PLANNING DEPARTMENT – Development Review Services

RE: **Hotel Albuquerque** – 800 Rio Grande Blvd., NW
Conceptual Grading and Drainage Plan
Engineer's Stamp Date 6-20-2014 (File: J13D066)

CONCEPTUAL GRADING AND DRAINAGE PLAN

SDP-3.1

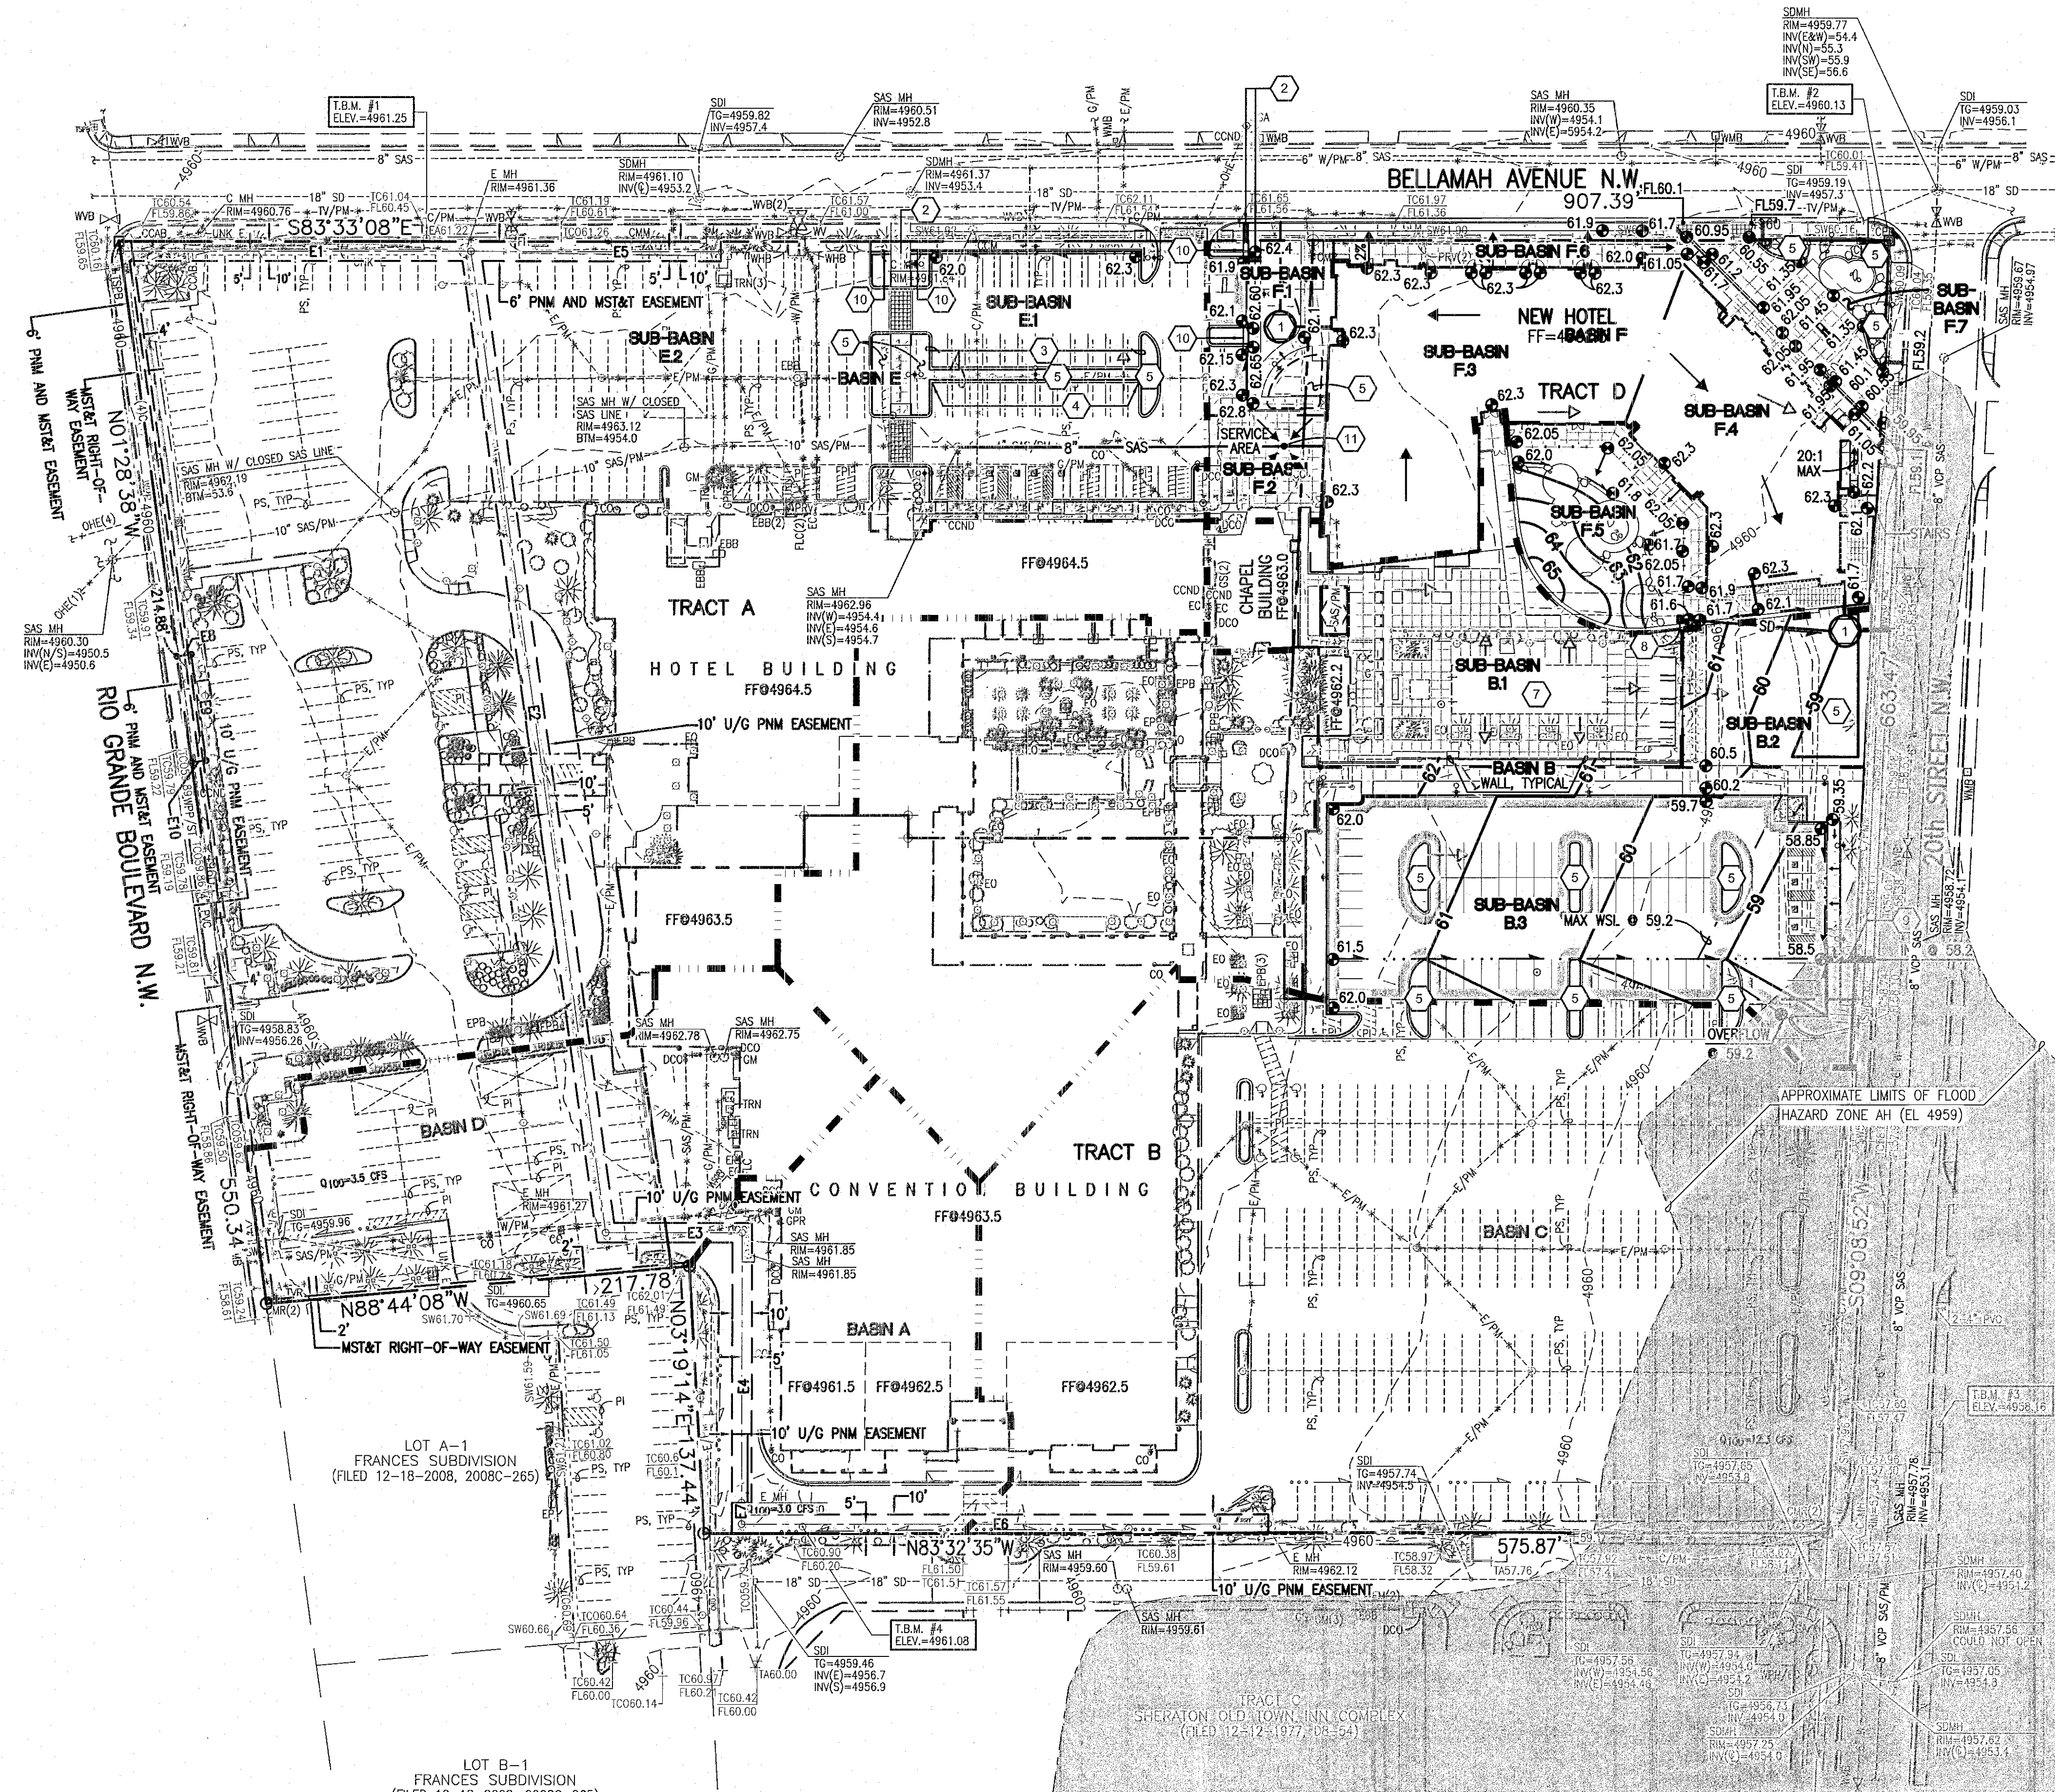
The **Conceptual Grading and Drainage Plan** received 6-23-14 was submitted in order to support an amendment to an existing Site Development Plan for the Sheraton Old Town Inn Complex. The amendment to the existing Site Development Plan is to remove Tract D from the Site Plan and will only include Tracts A and B. It is noted that Tracts A, B, and D will share parking, access, cross-lot drainage, and private utilities. Since the **Conceptual Grading and Drainage Plan** is essentially the approved Drainage Management Plan from the Sheraton Old Town Drainage Master Plan (Engineer's Stamp Date 6-23-2014), this plan is also approved for DRB action.
